**GENOA CHARTER TOWNSHIP  
PLANNING COMMISSION PUBLIC HEARING  
OCTOBER 13, 2020 (TUESDAY)  
6:30 P.M.  
AGENDA**

<b>Attention:</b>	Kelly Van Marter, AICP Assistant Township Manager and Planning Director
<b>Subject:</b>	Proposed rezoning from OSD to HDR (Review #1)
<b>Location:</b>	Grand River Avenue – north side of Grand River, west of Char-Ann Drive
<b>Zoning:</b>	OSD Office Service District

<b>Attention:</b>	Kelly Van Marter, AICP Planning Director and Assistant Township Manager
<b>Subject:</b>	UPS Howell – Site Plan Review #2
<b>Location:</b>	1183 Fendt Drive – east side of Fendt Drive, north of Grand Oaks Drive
<b>Zoning:</b>	IND Industrial District

**Re: UPS Parking Lot  
Site Plan Review No. 2**

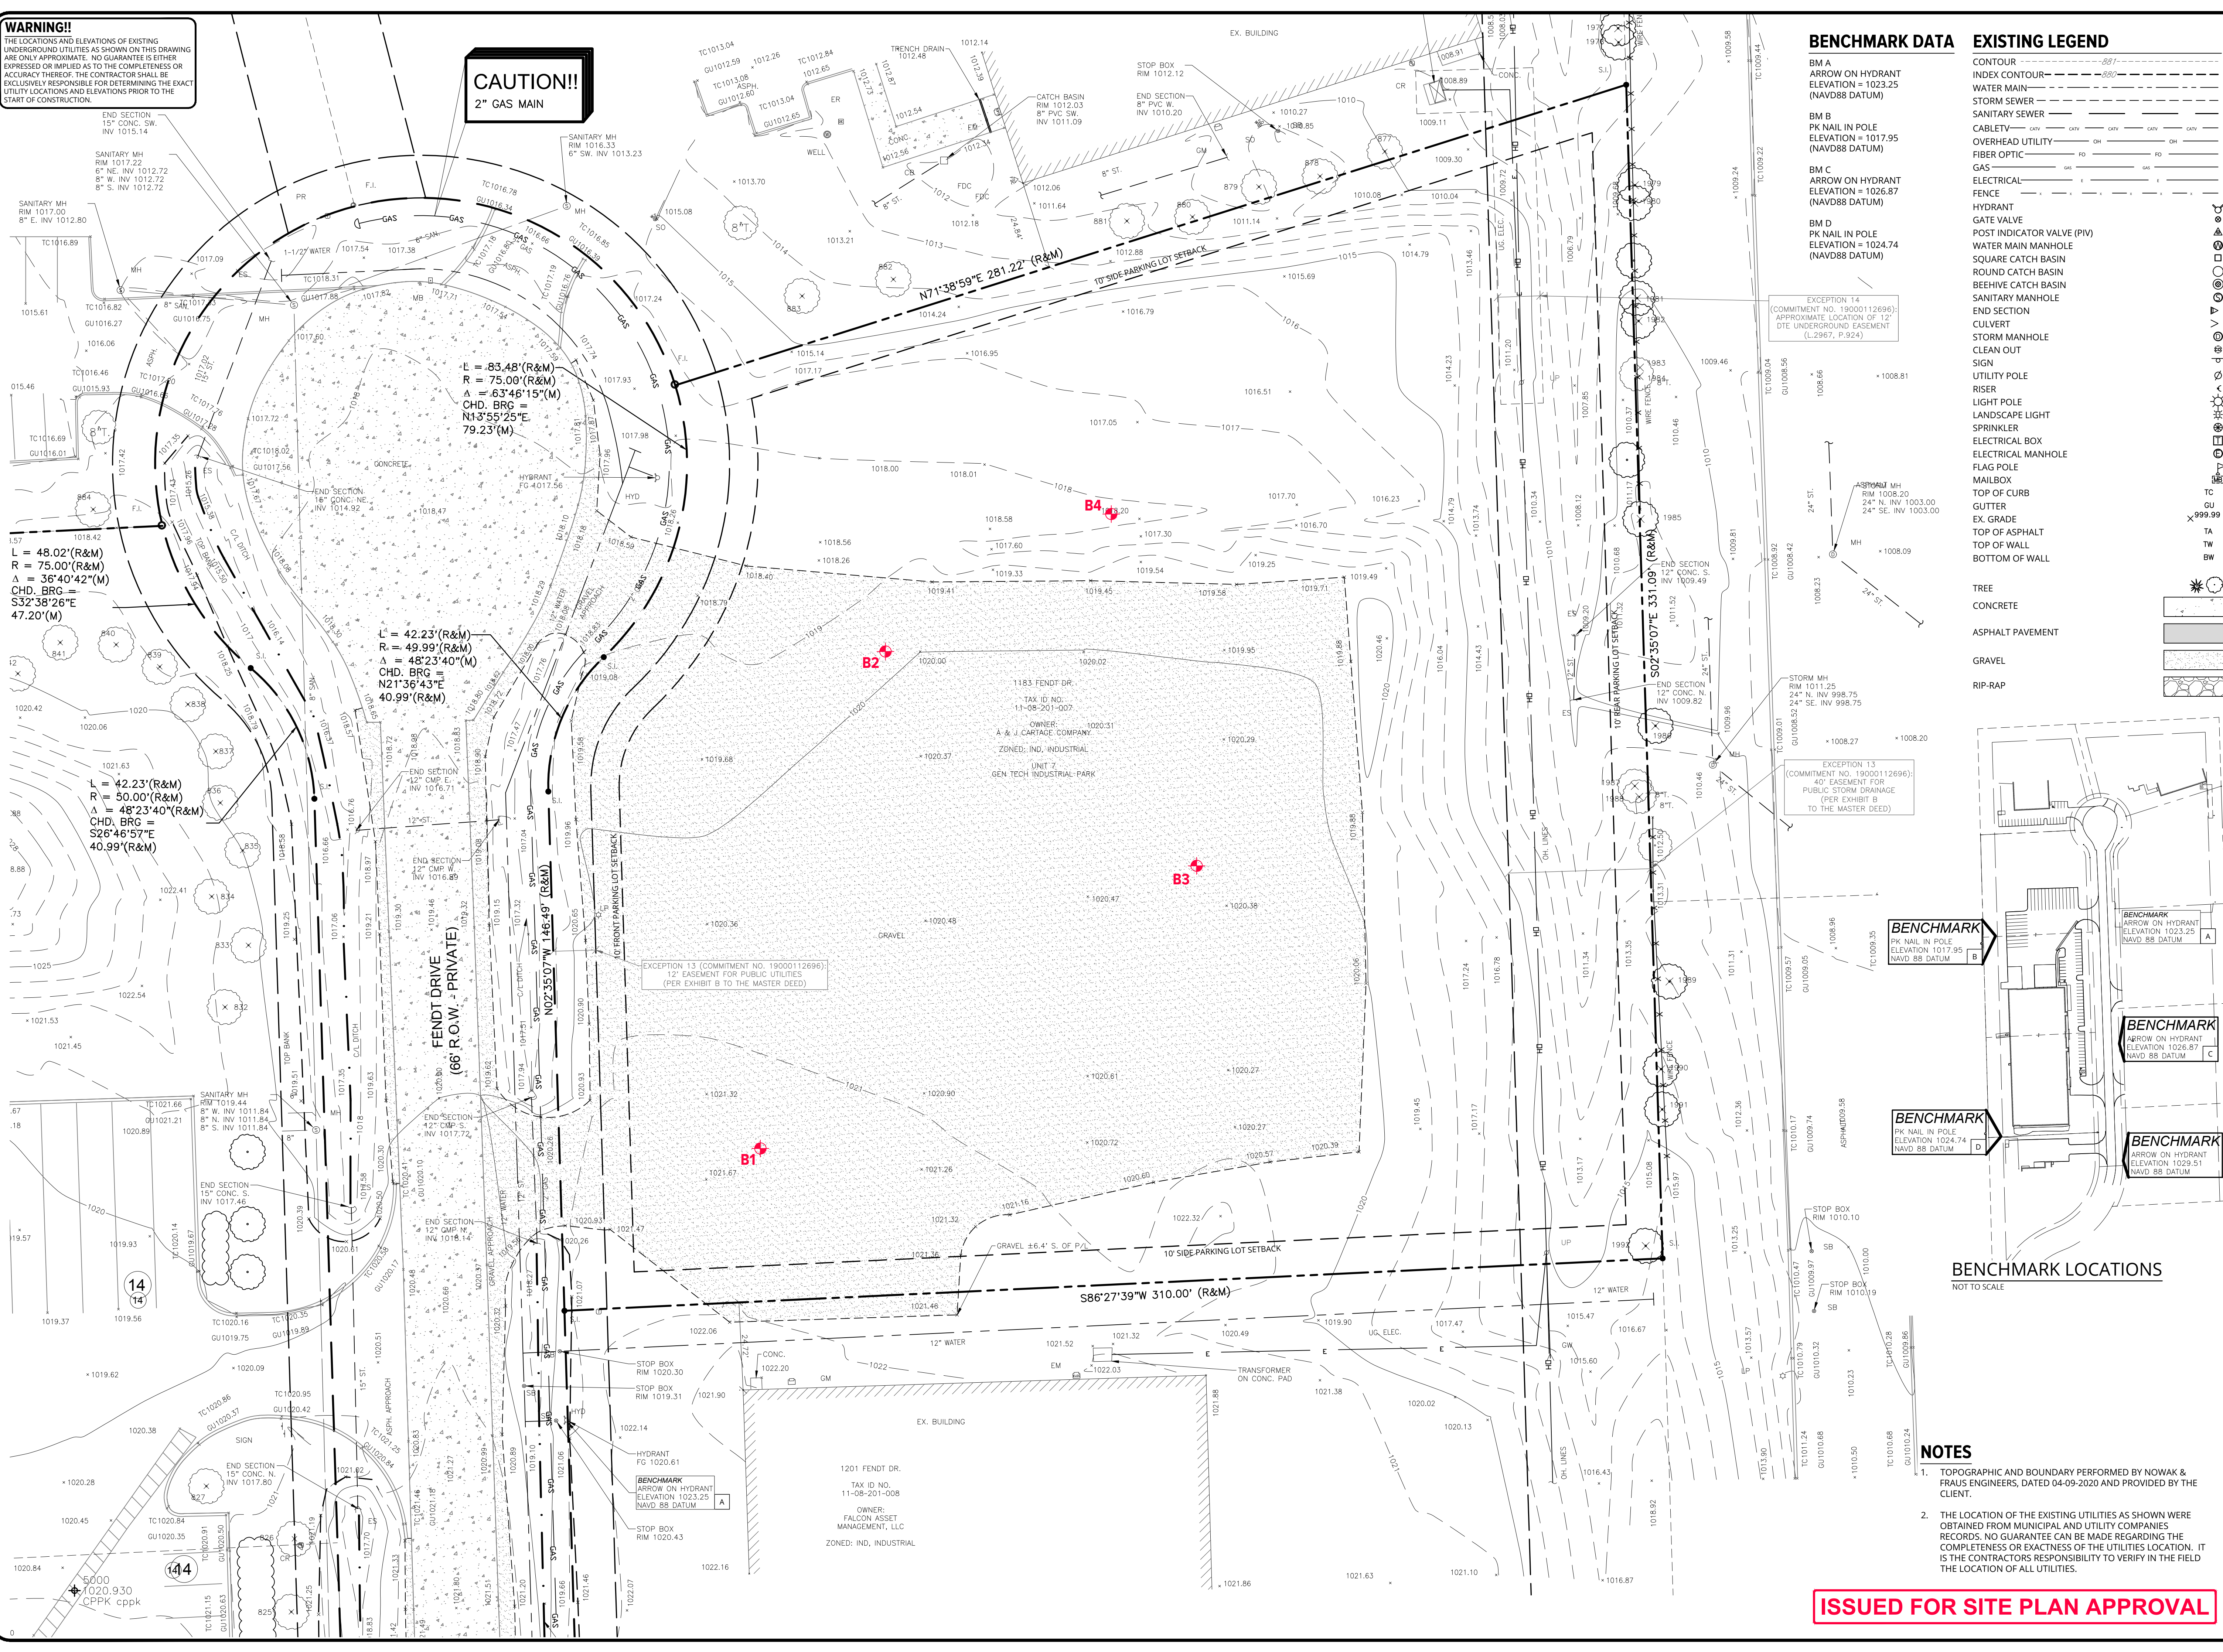
Additionally, the 300-foot standard of Section 14.02.03 is not met. Based on Sheet C-600, the distance is approximately 310 feet. The applicant will need to obtain a variance from the ZBA to exceed this standard.

Lastly, use of the parking lot for outdoor storage is prohibited. By definition, “outdoor storage” occurs when goods, materials, or vehicles are kept in the same place for more than 24 hours. A note has been added Sheet C-600 acknowledging this standard.

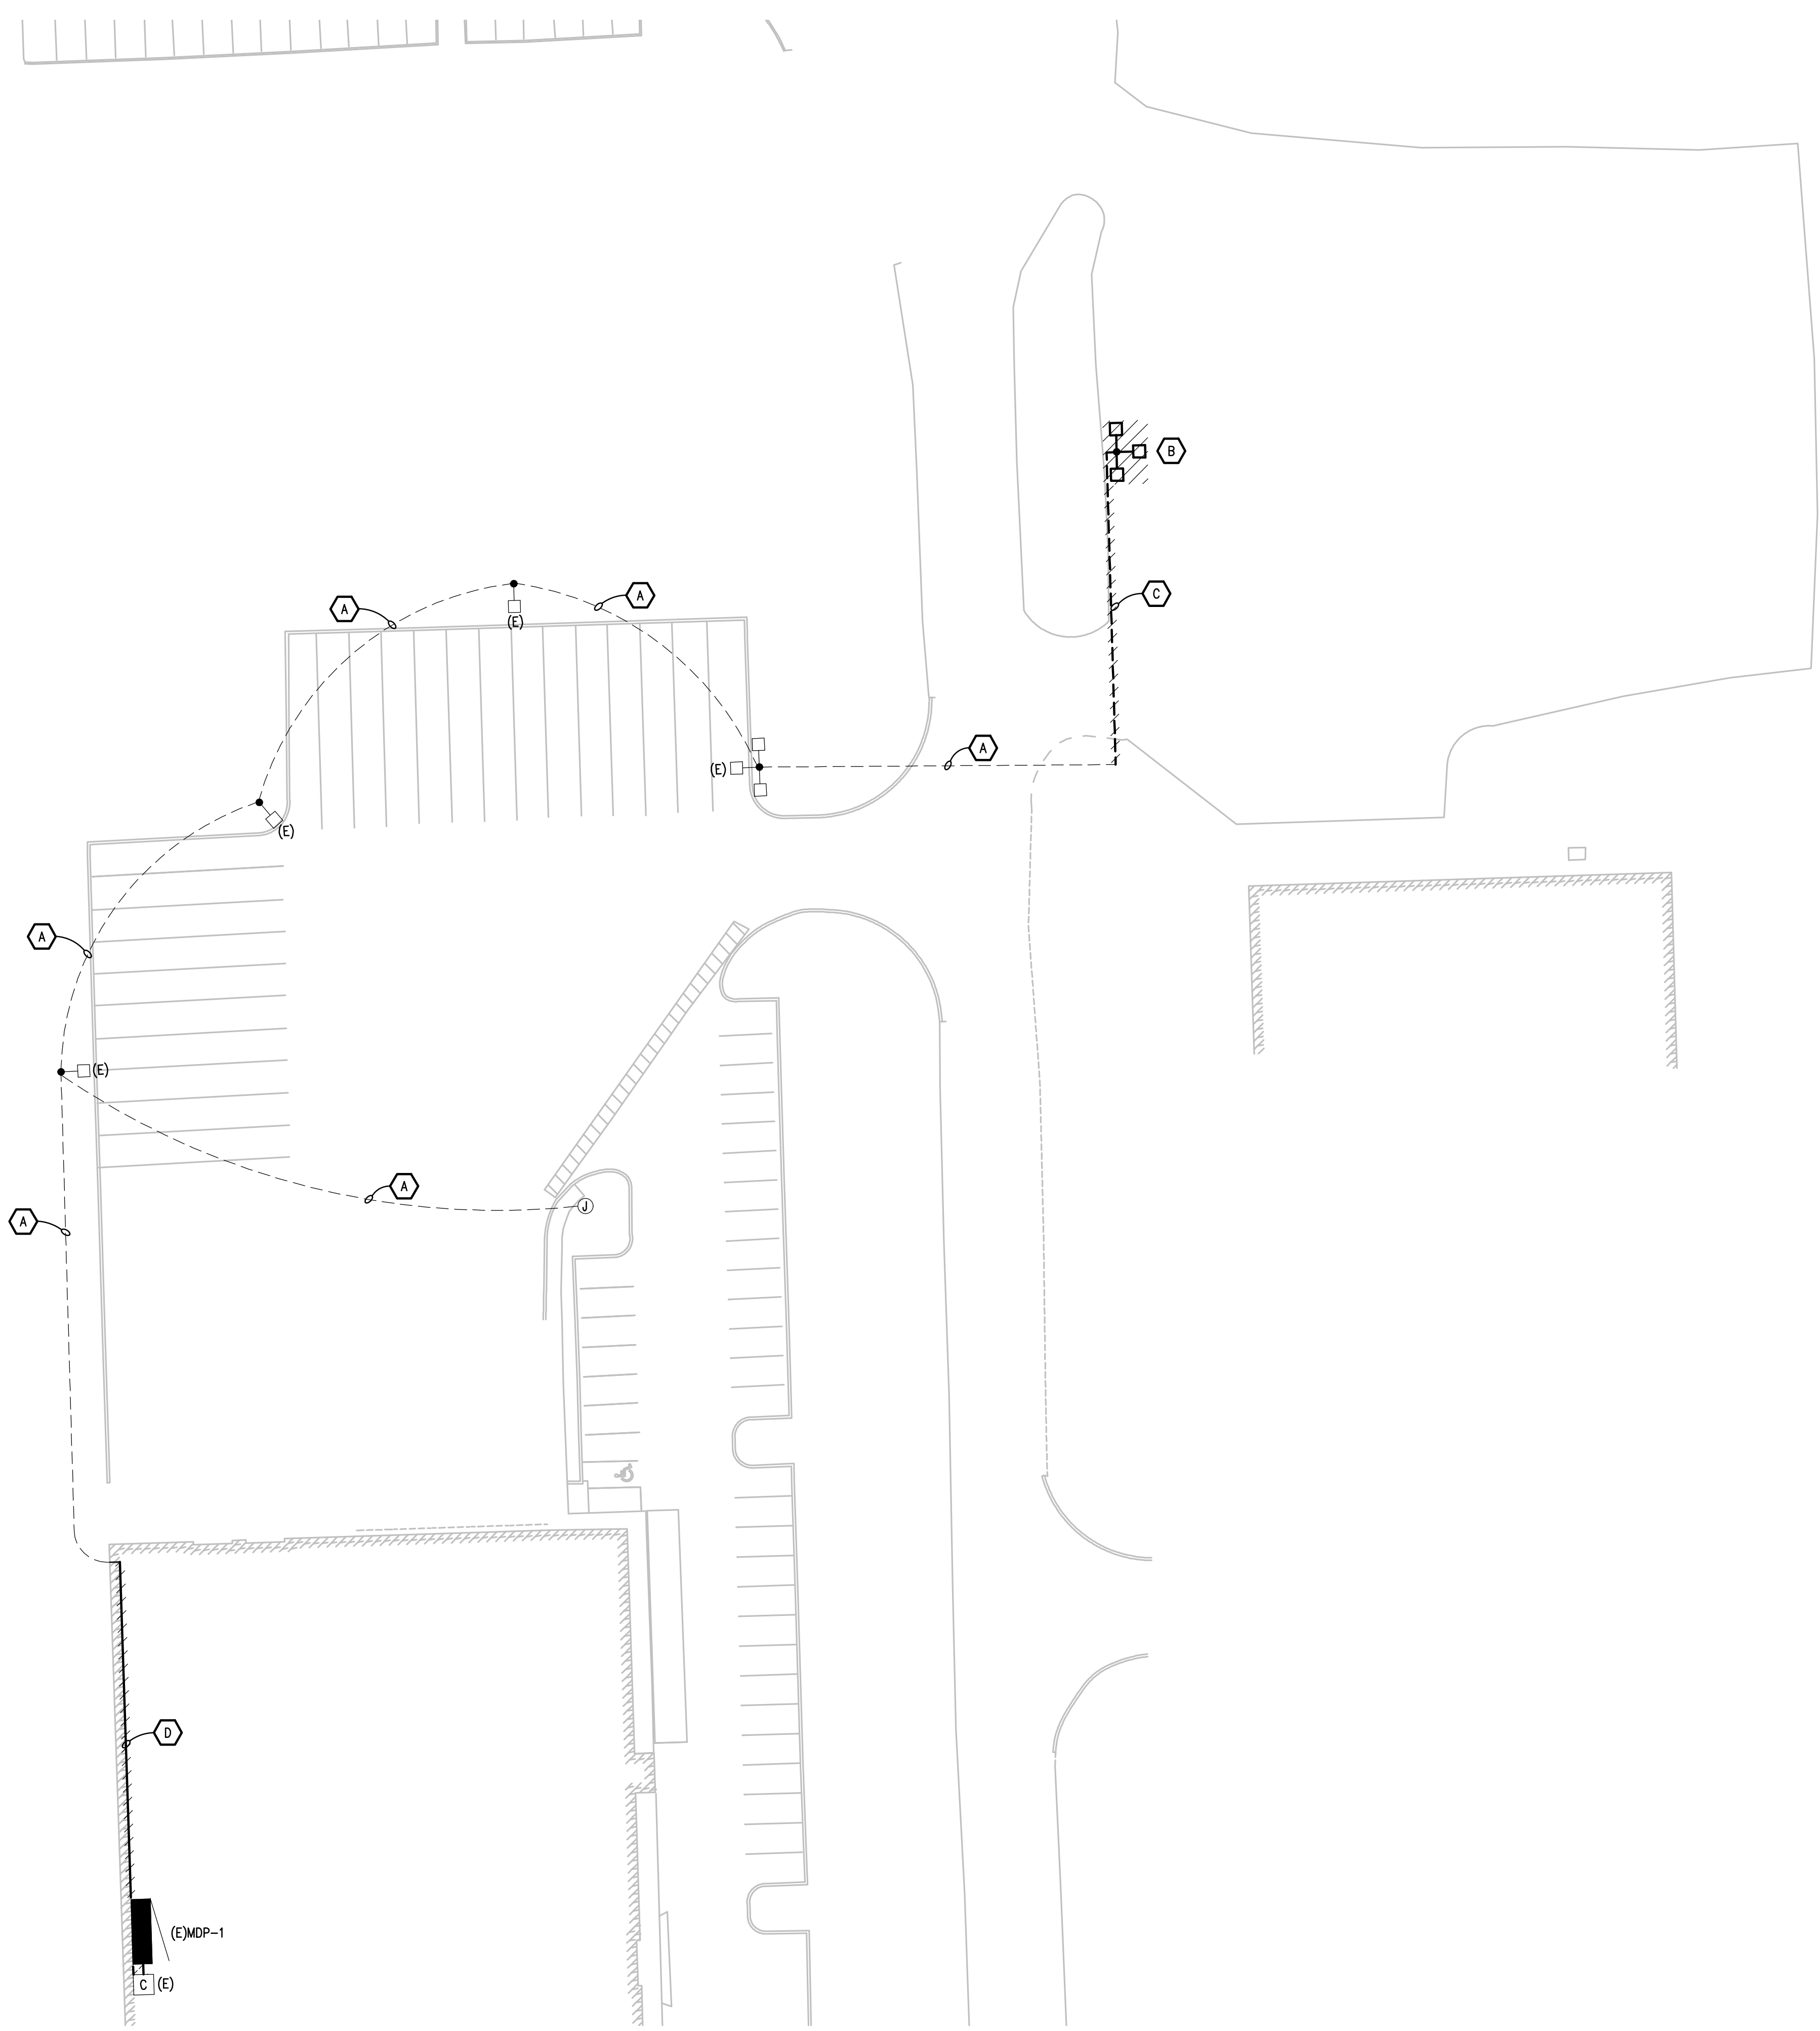
A note has been added to Sheet E-004 indicating the use of 30-foot tall light poles, which also complied with Ordinance standards.
